Product Change Notification

1. ECR #: 168943
Notification #: 408

- TSM - .025 SQ. TERMINAL STRIPS

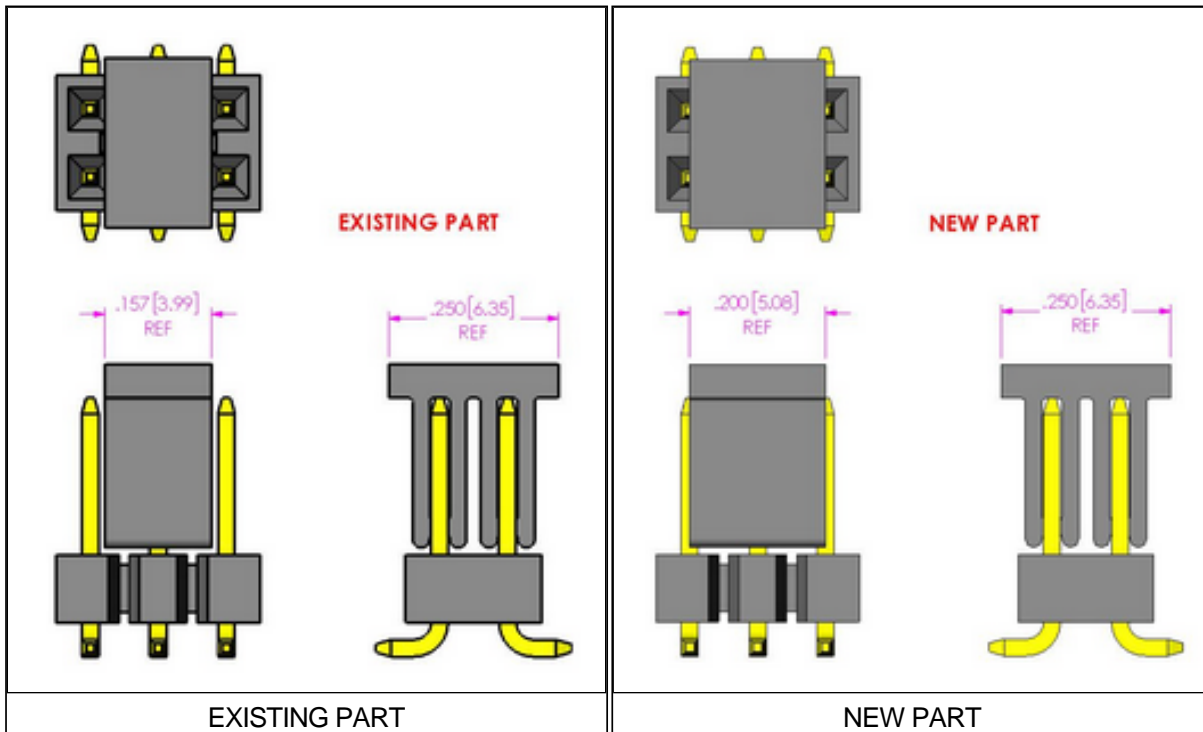
Change the 03 position connector pick and place pad from .157x.250 to .200x.250

New pad is .200" long where as old pad was .157" long. Both old and new pad have the same width at .250"

Change is being made to improve pick and place pad placement. The change is being made for -P option for -03 position with -TR packaging.

- Form - Pick and place pad option---03 position will use new pick and place pad. This is a rolling
